TENNESSEE VALLEY AUTHORITY

August 8, 1980

A TVA-NRC meeting was held on July 29, 1980, to discuss the design of the TVA interim distributed ignition system for control of hydrogen in the Sequoyah Nuclear Plant containment. Enclosed are TVA's complete responses to 10 of the 11 action items requested of TVA during the July 29, 1980, meeting. Enclosure 1 is a list of the action items with a summary of the TVA response. Action item 7b, an analysis of heat fluence delivered to equipment and resultant equipment temperature environment will be submitted on or before August 12, 1980.

TVA ACTION ITEMS FROM JULY 29, 1980, MEETING
ON INTERIM DISTRIBUTED IGNITION SYSTEM

CONTAINMENT
 LIGHTING FIXTURE
 EL 792.0'
 FIGURE 5

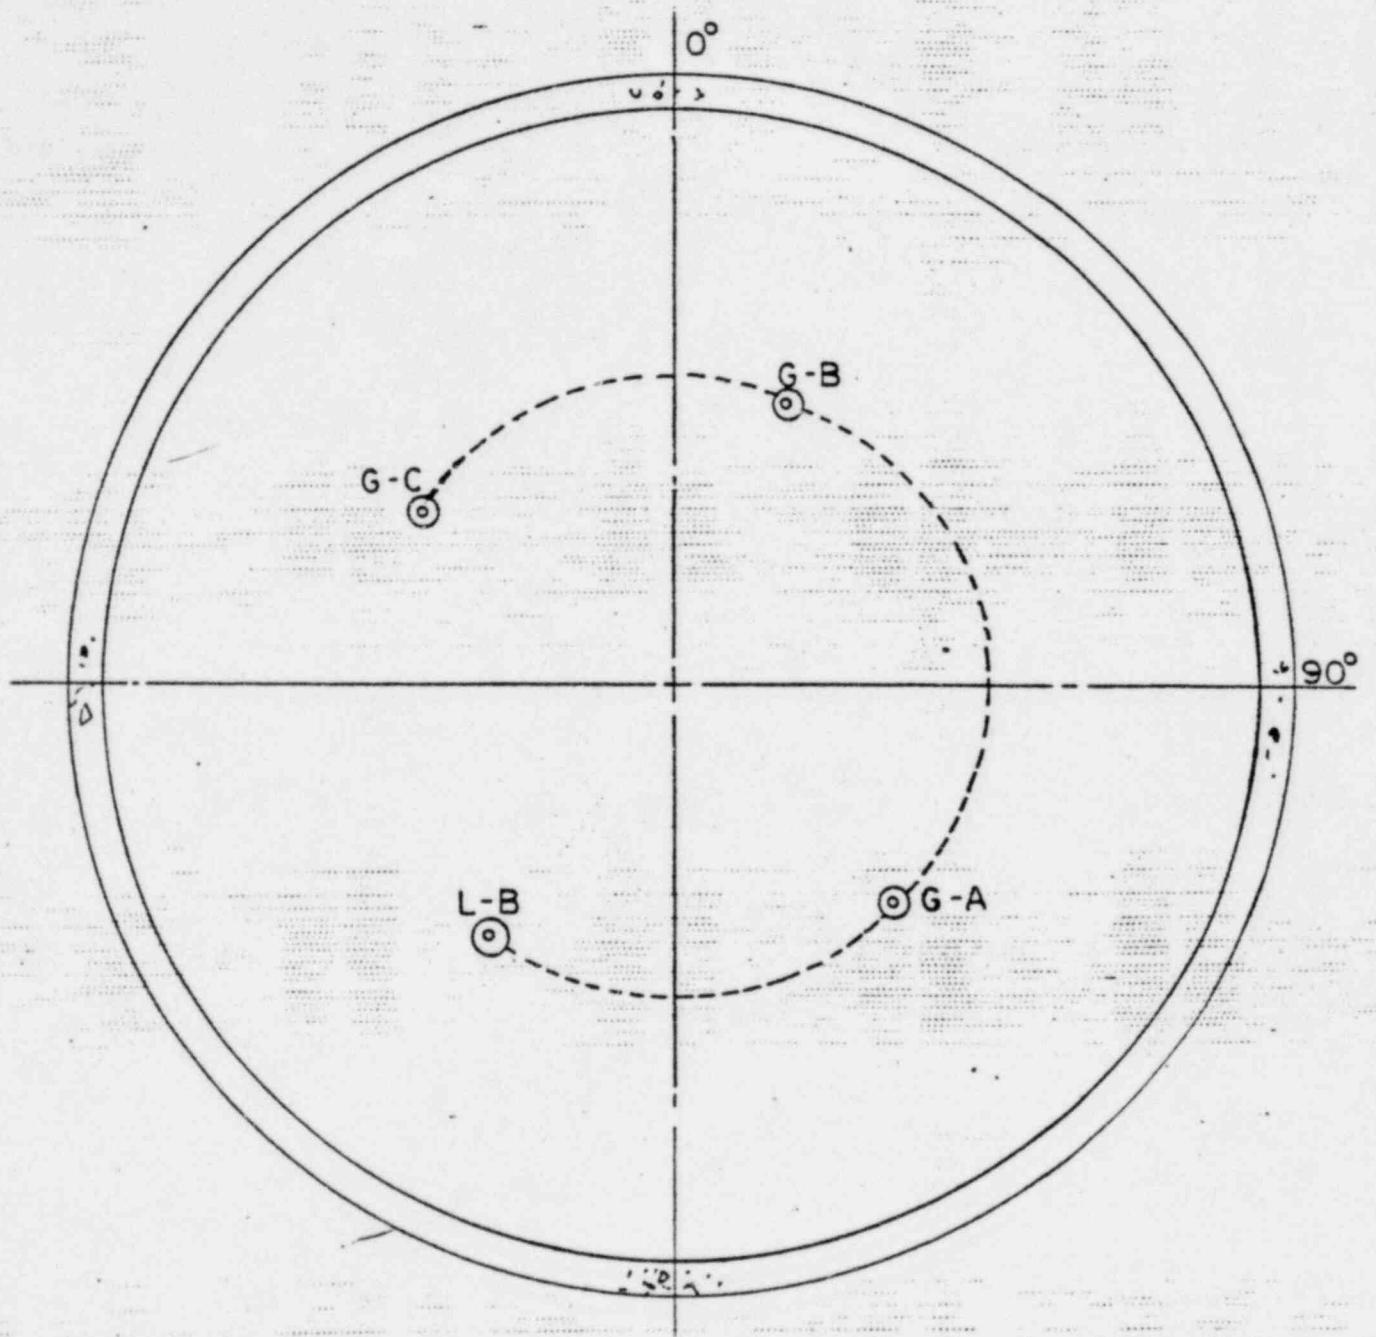
2. Location Drawings - Attached are the location drawings, figures 1 to 6, for each elevation.
3. Mounting Details - Attached is a drawing showing mounting details, figure 14.

- 5b. Location of Hydrogen Monitor Intakes - See figures 1-6.
6. Hydrogen Monitor Description - See Enclosure 2.
- 7a. List of Components Required after Hydrogen Burns - See Enclosure 3.

FIGURE 8

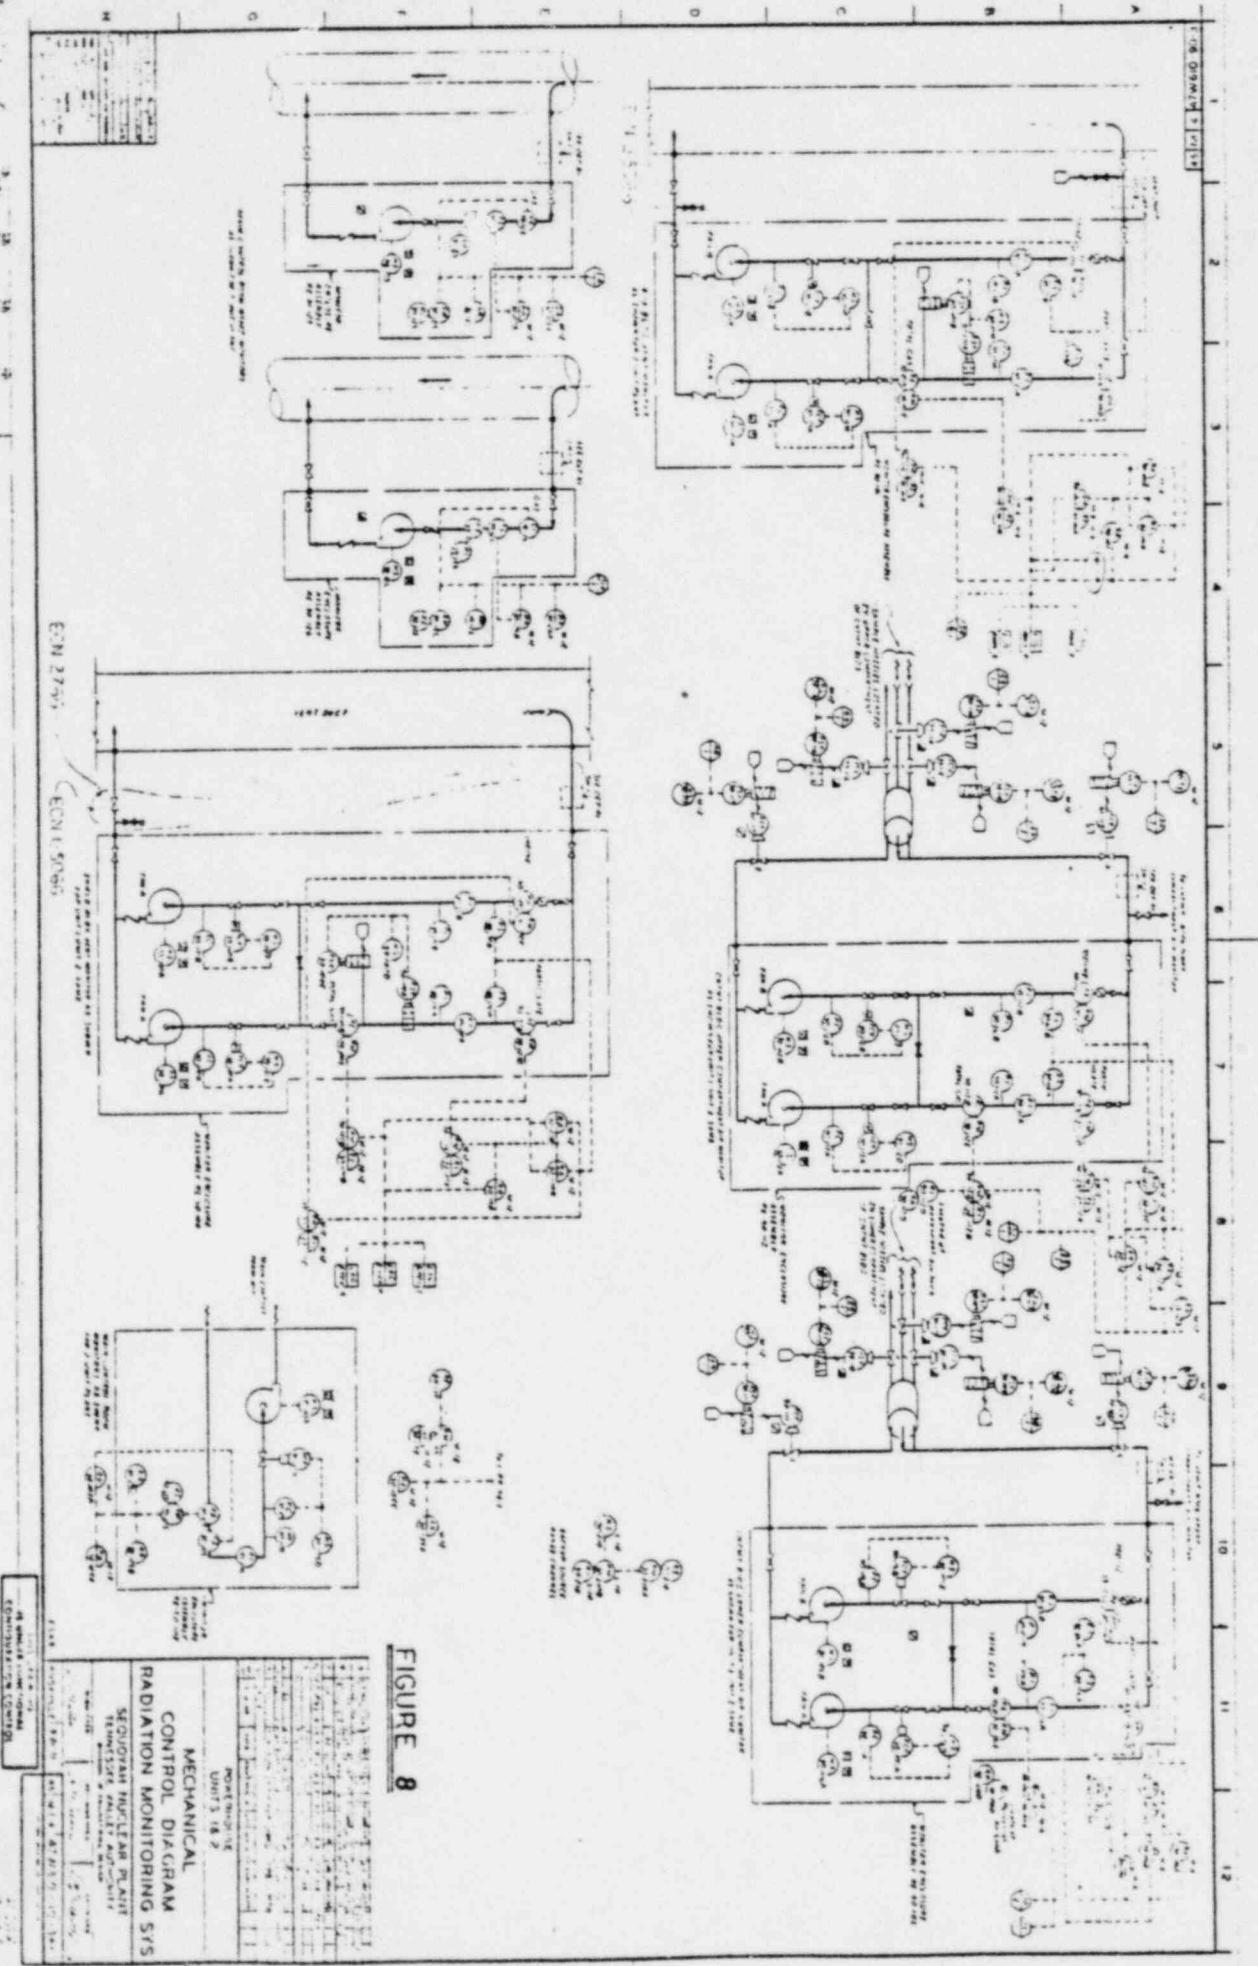
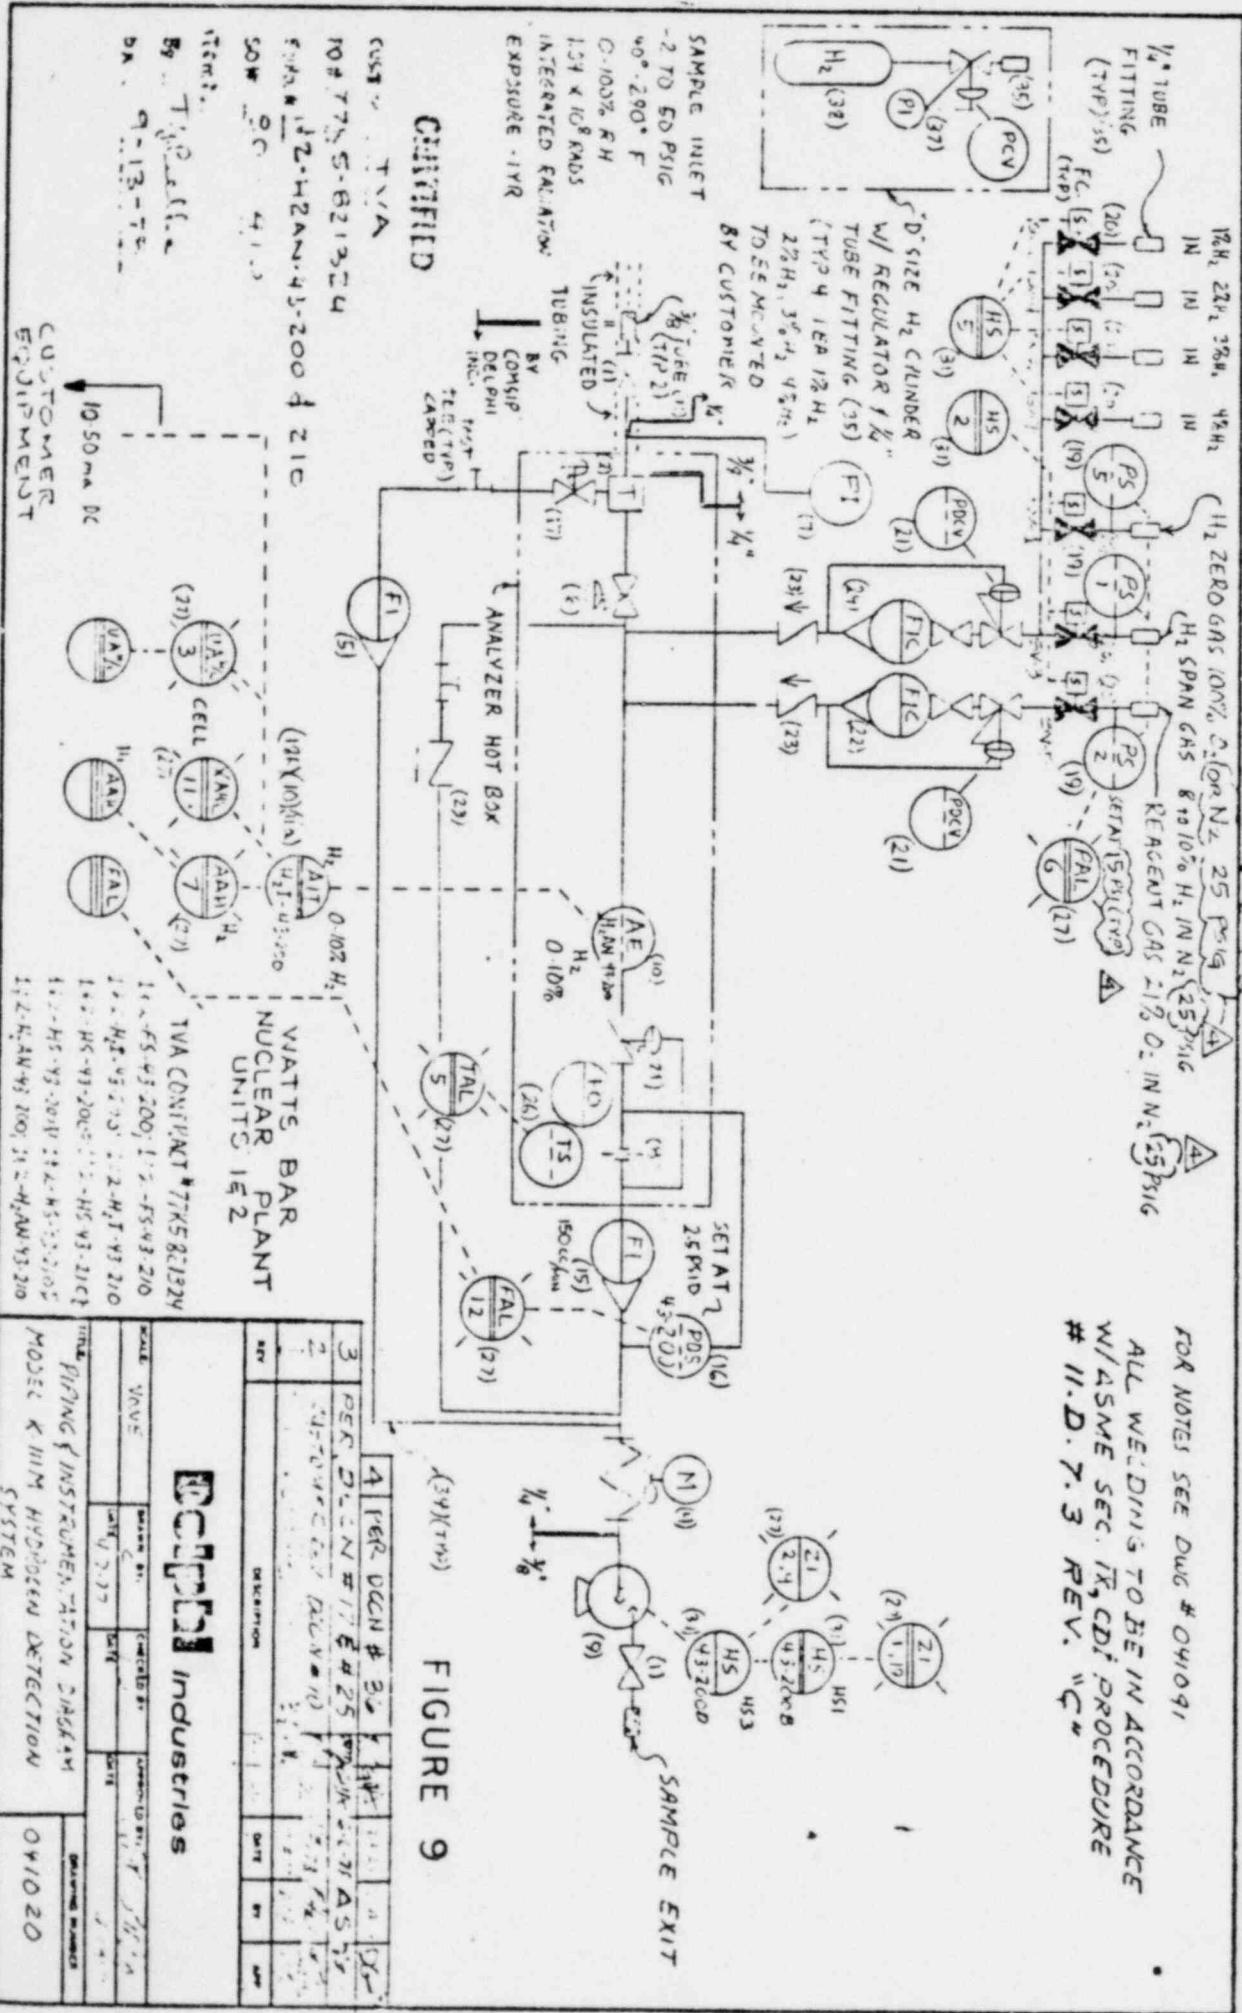
hydrogen concentrations between 0 and 10 percent with an accuracy of one percent full scale. A schematic drawing of an analyzer is given in Figures 8 and 9. Sample suction and expulsion locations are shown in Figures 10, 11, 12, and 13.
